| Settlement | Mosstodloch |
| Site Address | Land to the far east of Stynie Road (Parcel 3, Phase 1) |
| Ref Number | R6A |
| Bid Summary | Residential development (120 houses) |

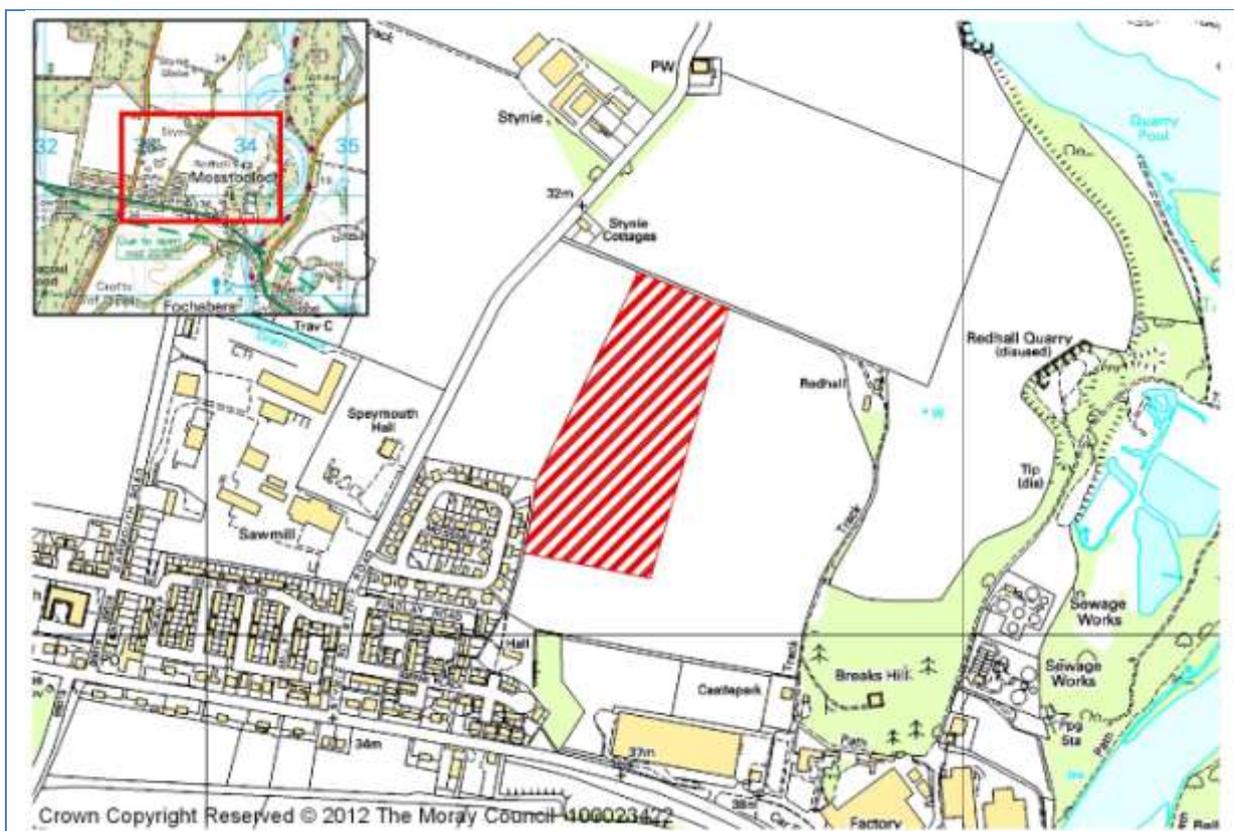
| Transportation | <p>Transport Scotland has provided the following comment on the potential development sites to the north of the bypass:</p> <p>“The sites identified comprise a total of over 500 houses. Due to the nature of this potential development it will be necessary to establish the potential impact on the trunk road network and the nature and scale of the mitigation measures identified and then agreed with Transport Scotland. This will ensure that any necessary mitigation measures can be identified early in the process and included within the Proposed Plan. This response assumes that the Fochabers and Mosstodloch Bypass project is completed in advance of the development work and the existing A96 in this area reverts back to the Moray Council in due course.”</p> |

| | <p>TMC Transportation Services has advised that development of the site may be acceptable subject to more detailed investigation at a later stage. A Transport Assessment will be required for this phase plus the whole of Parcel 3. Drainage for the old A96 is believed to run along the western boundary of this site and access to this drainage provision must be retained and upgraded as part of any development. The footway will need to be upgraded and cycleway provided along Stynie Road into the site. Pedestrian connections to the adjacent Mossmill Park will need to be provided and bus stops upgraded. Contributions will be sought towards upgrading the public transport infrastructure. Early years contributions to bus services will be sought if these are diverted along the U18E Stynie Road, through Parcel 4 to Garmouth Road. Two vehicular accesses onto the U18E Stynie Road through connections to the adjacent development 10/01276/APP will be needed.</p> <p>A core path follows the northern boundary of the site leading to Redhall Cottages, Breaks Hill and beyond. An aspirational core path is located to the west of the site along Stynie Road. This links Garmouth to Mosstodloch.</p> <p>National Cycle Route 79 (NCR 79) follows the route of the aspirational core path.</p> |
| <p>Flooding</p> | <p>The site is not at risk of flooding (source: SEPA flood maps, 2012) although there is an area of known flood risk at the existing industrial estate and consideration should be given to the extent of this flood risk before planning permission is granted. The size of the proposed development overall could have an adverse impact on the surface water and catchment of Mosstodloch and consideration should be given to the accumulation effect this may have. A regional SUDS scheme may be an appropriate way to deal with the increased surface water run-off that will occur rather than individual site-specific SUDS. Should a regional scheme be promoted it may provide an opportunity to address the surface water flood risk at the existing industrial estate. Drainage should not increase the flood risk to neighbouring property. SUDS and a construction phase water management plan are required. If a</p> |

| Landscape | <p>The land forms part of a larger agricultural field that slopes upwards to the east where Redhall Cottages sit at an elevated position overlooking the land. Phase 1 is less elevated than Phase 2 which is bounded by an informal track through the wooded Breaks Hill which leads to the River Spey. There are no natural features within the field to differentiate the proposed phases of development. A post and wire fence separates Phase 3 from the remainder of the field. A vehicular track leading to Redhall Cottages follows the northern boundary of the site whilst a post and wire fence and telegraph poles form the western boundary with the consented R1 development and proposed parcel 2.</p> |
| Cultural Heritage | <p>Archaeological Services have stated that taking into consideration the results of the evaluation undertaken in Site R1 in 2008, which revealed several undated pits, the cropmark site of a prehistoric settlement within Parcel 3 (SMR Ref No NJ36SW0036), and the other surrounding sites within the vicinity, there is potential for archaeological remains within the bid areas. Therefore an</p> |

| | <p>archaeological evaluation would be required for Parcels 1, 3-5 prior to development commencing. The mitigation for R1 has already been completed.</p> <p>No other cultural heritage assets would be affected by the development of this site.</p> |
| Overall Planning Assessment | <p>The proposal represents a large extension to the settlement beyond the 60 units required for the new LDP. Development would need to be considered in the wider context given there are no natural features to contain smaller areas within the landscape. Furthermore, access would need to be taken through Parcel 2 which would create a relatively convoluted and remote route from the village centre. Properties would be somewhat distant from facilities such as the primary school and shops. For the above reasons it is not intended to support residential development on Phases 1, 2 or 3 of Parcel 3.</p> |

| Ref Number | R6B |

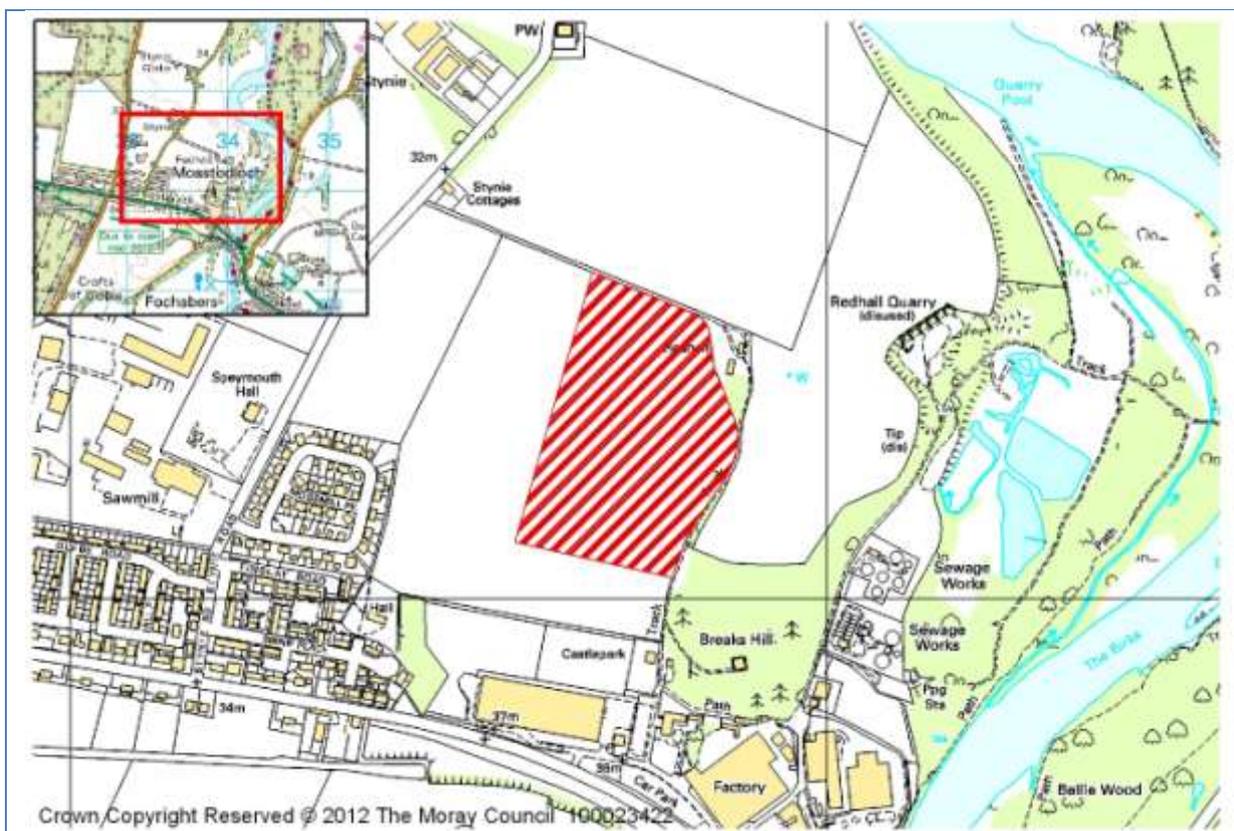
| | <p>TMC Transportation Services has advised that development of the site may be acceptable subject to more detailed investigation at a later stage. A Transport Assessment will be required for this phase plus the whole of Parcel 3. Drainage for the old A96 is believed to run along the western boundary of this site and access to this drainage provision must be retained and upgraded as part of any development. The footway will need to be upgraded and cycleway provided along Stynie Road into the site. Pedestrian connections to the adjacent Mossmill Park will need to be provided and bus stops upgraded. Contributions will be sought towards upgrading the public transport infrastructure. Early years contributions to bus services will be sought if these are diverted along the U18E Stynie Road, through Parcel 4 to Garmouth Road. Two vehicular accesses onto the U18E Stynie Road through connections to the adjacent development 10/01276/APP will be needed.</p> <p>Core path ER138 follows the northern boundary of the site leading to Redhall Cottages, Breaks Hill and beyond. An aspirational core path is located to the far west of the site along Stynie Road. This links Garmouth to Mosstodloch. National Cycle Route 79 (NCR 79) follows the route of the aspirational core path.</p> |

| Flooding | The site is not at risk of flooding (source: SEPA flood maps, 2012) although there is an area of known flood risk at the existing industrial estate and consideration should be given to the extent of this flood risk before planning permission is granted. The size of the proposed development overall could have an adverse impact on the surface water and catchment of Mosstodloch and consideration should be given to the accumulation effect this may have. A regional SUDS scheme may be an appropriate way to deal with the increased surface water run-off that will occur rather than individual site-specific SUDS. Should a regional scheme be promoted it may provide an opportunity to address the surface water flood risk at the existing industrial estate. Drainage should not increase the flood risk to neighbouring property. SUDS and a construction phase water management plan are required. If a soakaway is to be used, infiltration tests should be carried out at this location where the soakaway is to be sited, generic infiltration tests may not provide an accurate indication of ground suitability for soakaways to function properly. If the development is to be phased as suggested in the proposal document then the SUDS should be designed in such a way that is operational for the initial phase and suitably sized to receive the future phases of development that make up this proposed site. |
| Landscape | The land forms part of a larger agricultural field that slopes upwards to the east where Redhall Cottages sit at an elevated position overlooking the land. Phase 1 is less elevated than Phase 2 which is bounded by an informal track through the wooded Breaks Hill which leads to the River Spey. There are no natural features within the field to differentiate the proposed phases of development. A post and wire fence separates Phase 3 from the remainder of the field. A vehicular track leading to Redhall Cottages follows the northern boundary of the site whilst a post and wire fence and telegraph poles form the western boundary with the consented R1 development and proposed parcel 2. |

| Overall Planning Assessment | The proposal represents a large extension to the settlement beyond the 60 units required for the new LDP. Development would need to be considered in the wider context given there are no natural features to contain smaller areas within the landscape. Furthermore, access would need to be taken through Parcel 2 which would create a relatively convoluted and remote route from the village centre. Properties would be somewhat distant from facilities such as the primary school and shops. For the above reasons it is not intended to support residential development on Phases 1, 2 or 3 of Parcel 3. |
| Other | The site is located within Mosstodloch Primary School and Milne's Secondary School (Fochabers) catchments. Noise from the adjacent Baxters Factory may be an issue. |

| Ref Number | R7B |

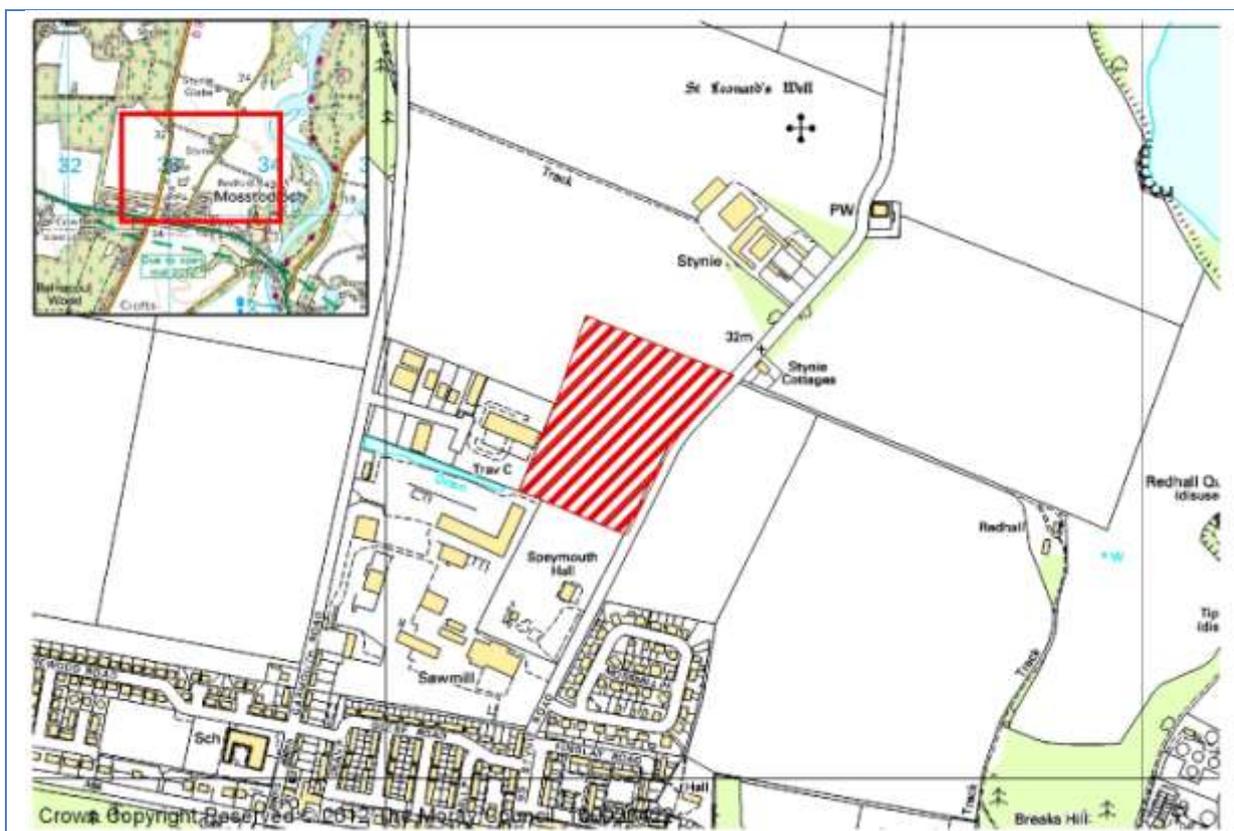
| | <p>TMC Transportation Services have advised that the site is suitable for development subject to more detailed investigations at a later stage. A Transport Assessment will be required for this phase plus the whole of the parcel 4. There are flooding issues on this site, high water table and inefficient SUDS/storage for adjacent developments. Two vehicular accesses onto the U18E Stynie Road will be required. Stynie Road will need to be widened to 5.5m along the site frontage although this is partly to be done as proposals for the adjacent development 10/01267/APP. Contributions towards upgrading the public transport infrastructure, and early years contributions to bus services if diverted along the U18E Stynie Road through Parcel 4 to Garmouth Road will be sought.</p> <p>A core path runs along Stynie Road and follows a relatively-well established vehicular track to Redhall Cottages to the east. This path is adjacent the eastern boundary of the proposed site. An aspirational core path from Garmouth to the village centre also follows the eastern boundary of the site. National Cycle Route 79 (NCR 79) follows the route of the aspirational core path.</p> |
| Environmental Health | <p>TMC Environmental Health has raised no comment and there are no known contaminated land issues.</p> <p>In order to ensure the amenity of future residential use is protected against the existing industrial uses adjacent, it may be necessary for the provision of a detailed noise impact assessment in terms of PAN 1/2011.</p> |

| <p>Landscape</p> | <p>The relatively flat area of land forms part of a larger agricultural field. There are no natural features to differentiate the parcel from agricultural land beyond or phases within it. The land gently slopes down towards the curtilage of the industrial estate. Although some scrub shields the industrial estate, the buildings are clearly visible from the site. Speymouth Hall and football pitch are located immediately to the south behind a row of trees and scrub. An attractive row of mature trees are located to the front of the hall along Stynie Road. Mature bramble bushes screen the site from the road. Stynie Farm is located to the north of the site.</p> |

| <p>Overall Planning Assessment</p> | <p>The proposal represents a large extension to the settlement beyond the 60 units required for the new LDP. The sawmill and industrial estate are located immediately adjacent the site, which could detrimentally impact on the amenity of potential residential properties. Given that development has generally taken place along the east-west axis with the consolidation of properties around the hub of the village, the extension north is at odds with the general pattern of development. The site is also relatively distant from facilities such as the primary school and shops. For the above reasons, it is not intended to support development of this site, particularly given there are other proposals that are more sustainable.</p> |
| <p>Other</p> | <p>The site is located within Mosstodloch Primary School and Milnes Secondary School (Fochabers) catchments. Noise from the adjacent sawmill and industrial estate could be an issue that requires further consideration.</p> |

| Ref Number | R8A |

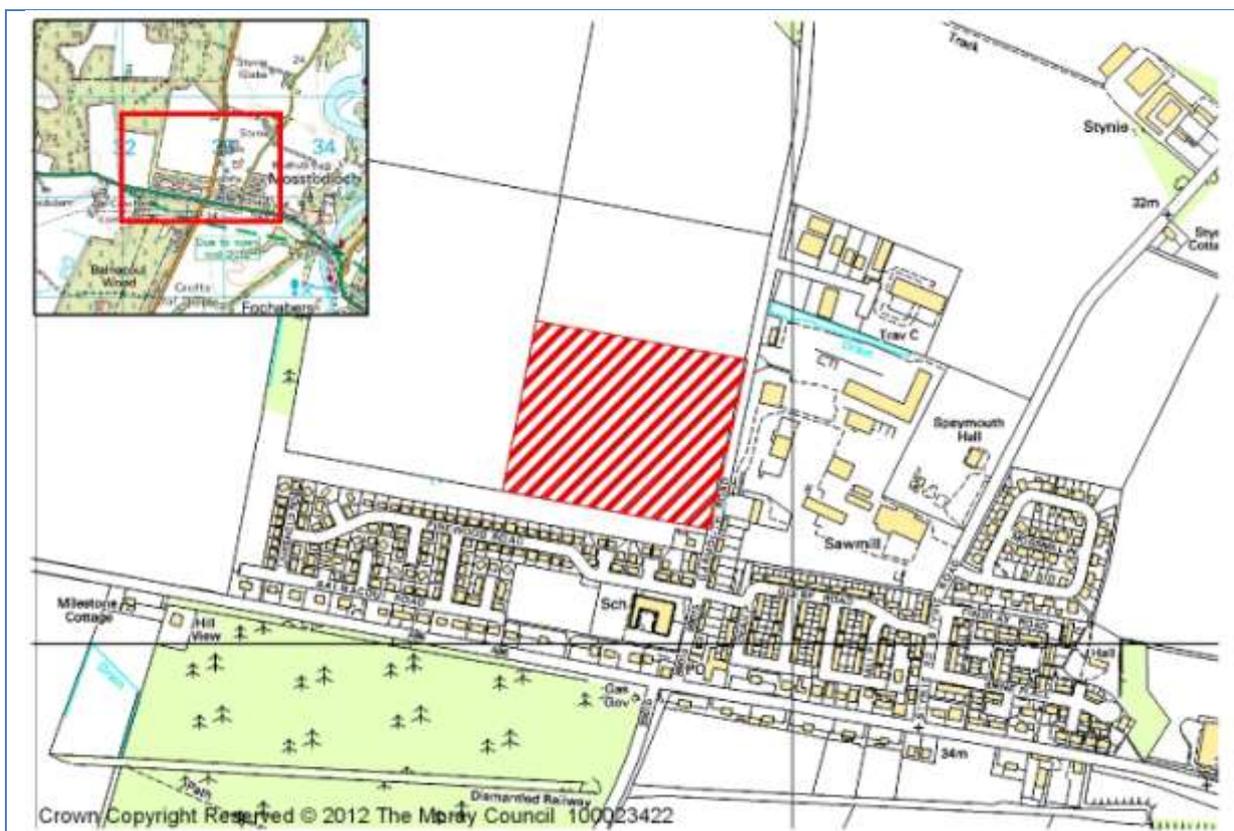
| | <p>TMC Transportation Services have advised that the site is unsuitable for development from a transport impact perspective due to the requirement for third party land. Should development be pursued a Transport Assessment will be required for this phase plus the whole of parcel 5. There are flooding issues on this site, high water table and inefficient SUDS/storage for adjacent developments. Visibility is constrained to the south by the boundary of a dwelling named Carmanda. The extension of a footway alongside Garmouth Road to the site requires third party land (Carmanda). Two vehicular accesses would be required. The extension and upgrade of the footway/cycleway along the Garmouth Road boundary of the site (third party land) will be required together with upgrading existing bus stops and the diversion of bus routes as part of the wider aspiration of the Crown Estate. Contributions will be sought towards upgrading public transport infrastructure and early years contributions to bus services if diverted along the U18E Stynie Road through Parcel 4 to Garmouth Road.</p> |
| <p>Environmental Health</p> | <p>TMC Environmental Health has advised that in order to ensure the amenity of future residential use is protected against the existing industrial uses adjacent, it may be necessary for the provision of a detailed noise impact assessment in terms of PAN1/2011. There are no known contaminated land issues.</p> |

| <p>Landscape</p> | <p>The flat area of land forms part of a larger agricultural field. Trees and scrub follow the southern boundary beyond which there is an informal recreational area and residential properties that sit at a lower level than the site. Bushes create a boundary with the land to the west which is also relatively flat. These bushes are denser along the boundary of Phase 1 as opposed to Phase 2. There are no natural features or vegetation to differentiate the two phases of parcel 5. Garmouth Road forms the eastern boundary of the site along which there is a post and wire fence and some vegetation. Telegraph poles cross the site from south-west to north-east.</p> |

| Overall Planning Assessment | <p>Although the proposal represents a large extension to the settlement beyond the 60 units required for the new LDP the site is well-located for accessing facilities such as the primary school and shops. Given that development has generally taken place along the east-west axis, developing part of the site conforms with the settlement pattern of consolidating properties around the hub of the village however, transportation and third party land ownership issues would have to resolved before development could be supported. Should these issues be overcome part of the site could be supported for residential development, with options for longer term growth into the balance to the north.</p> |
| Other | <p>The site is located within Mosstodloch Primary School and Milnes Secondary School (Fochabers) catchments. Noise from the adjacent sawmill and industrial estate may require further consideration.</p> |

| Ref Number | SITE 1, SITE 2, SITE 3, BOUND |

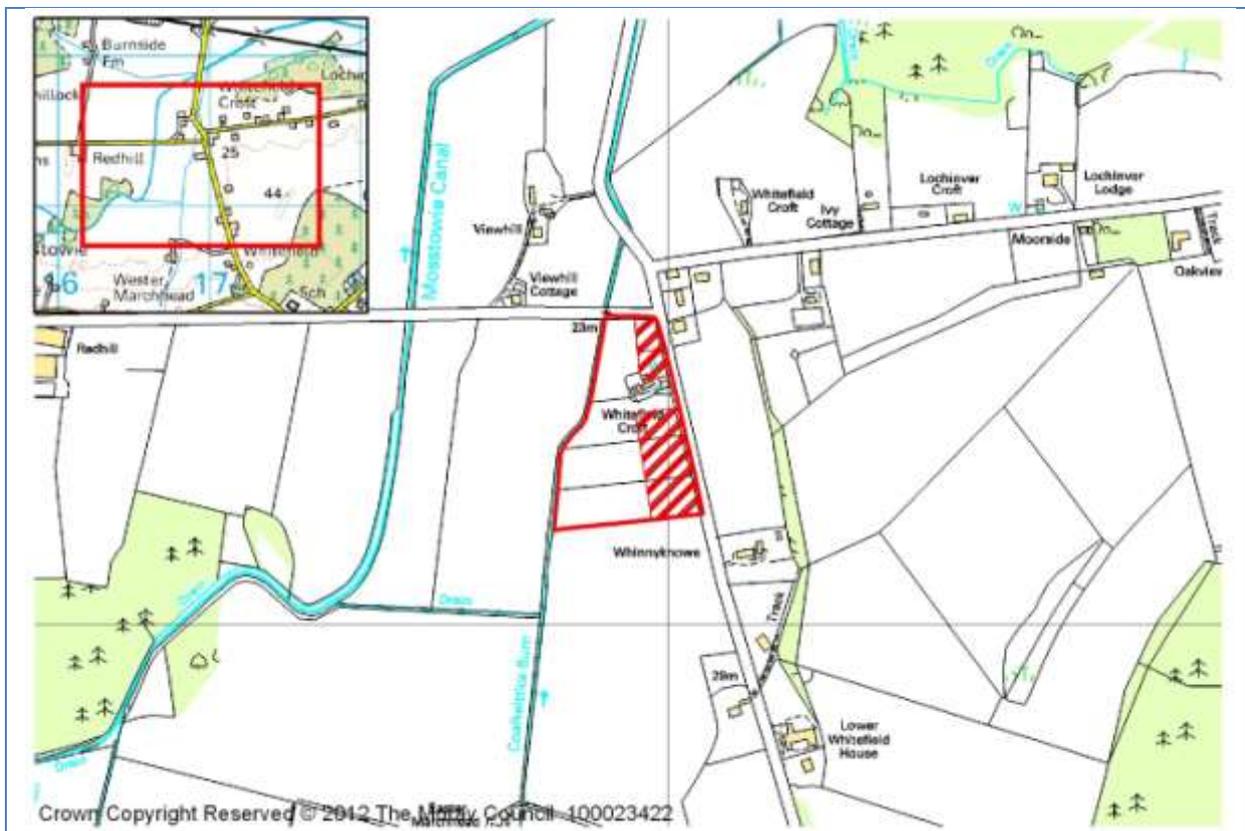
| Flooding | The western edge of the bid site is at risk of flooding 1 in 200 years. The LDP should be clearly worded to highlight that any |

| | development on the site would need to be supported by a satisfactory FRA. The outcome of the FRA may affect the extent of developable land available, but it is likely that part of the site can be developed at least. |
| Cultural Heritage | There are several cropmarks visible in the vicinity of this site consistent with prehistoric settlement (SMR Ref No NJ16SE0013 and NJ16SE0039). Therefore an archaeological watching-brief would be required at the outset of any development works for this bid site. |
| Overall Planning Assessment | The bid is for approximately 9 houses in the countryside. The bid does not request or propose rural community status for Mosstowie. This type of proposal for multiple houses in the countryside, outwith rural communities should be considered through the development management process, not the Local Development Plan. |
